# UNITED STATES PATENT AND TRADEMARK OFFICE

APPLICATION NO.	FILING DATE	FIRST NAMED INVENTOR	ATTORNEY DOCKET NO.	CONFIRMATION NO.
10/576,029	04/17/2006	Shigeo Kamamoto	4731-0132PUS1	8726
2292 7590 12/23/2010 BIRCH STEWART KOLASCH & BIRCH PO BOX 747 FALLS CHURCH, VA 22040-0747				
EXAMINER IRVIN, THOMAS W				
ART UNIT 3657		PAPER NUMBER		
NOTIFICATION DATE 12/23/2010		DELIVERY MODE ELECTRONIC

# Office Action Summary

## **DETAILED ACTION**

**Fig. 2 of Applicant's Drawings**

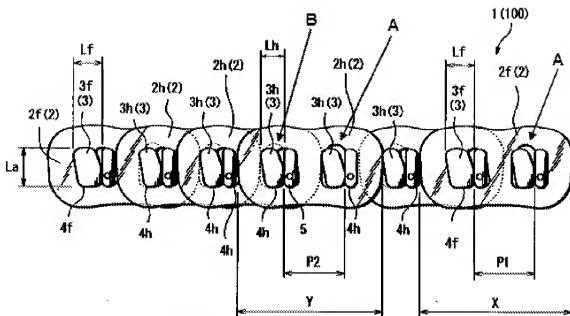
Amended claims 1, 2, and 6, all recite

*"at least one type of link possessing two through-holes of the same shape".*

Referring to applicant's remarks filed 05 November 2010, applicant relies on fig. 2 for support for the amendments to claims 1, 2, and 6. The examiner however feels that fig. 2, shown above, appears to show that the links do not possess through-holes of the same shape. Specifically, the examiner points to the center-most link, identified as the short link (2h). Link (2h) is shown to possess two through-holes (4h), but of differing shape (A,B). The figure appears to show that the curved portion (A) of the through-hole is present on the right through-hole and not present on the left through-hole. The dotted lines are understood to indicate that the right through-hole of the link located behind the

center-most link contains a through-hole having this curved portion (B). The examiner further points to the right-most link, identified as (2f), which appears to also possess two differing through-holes (4f, 4h with the curved portion A).

These two statements appear to support applicant's amendments. However, par. 0063 recites

*"The right and left through-holes 4 in one link 2 have mutually different configurations such as to permit the chain 1 to be circumferentially bent. When the term, the greater through-hole 4f or the thinner through-hole 4h is used herein, such a difference in the configuration is disregarded and all the through-holes 4 penetrated by the greater pins 3f are referred to as the greater through-hole 4f whereas all the through-holes 4 penetrated by the thinner pins 3h are referred to as the thinner through-hole 4h."*

Fig. 2, and the statements: that the right and left through-holes (4) in each link have mutually different configurations; and that the reference terms (4f) and (4h) are

merely used to identify the size of the through-hole and not the shape, appear to be in opposition to applicant's amendments. Therefore, the claims are rejected as containing subject matter which was not described in the specification in such a way as to reasonably convey to one skilled in the relevant art that the inventors, at the time the application was filed, had possession of the claimed invention.
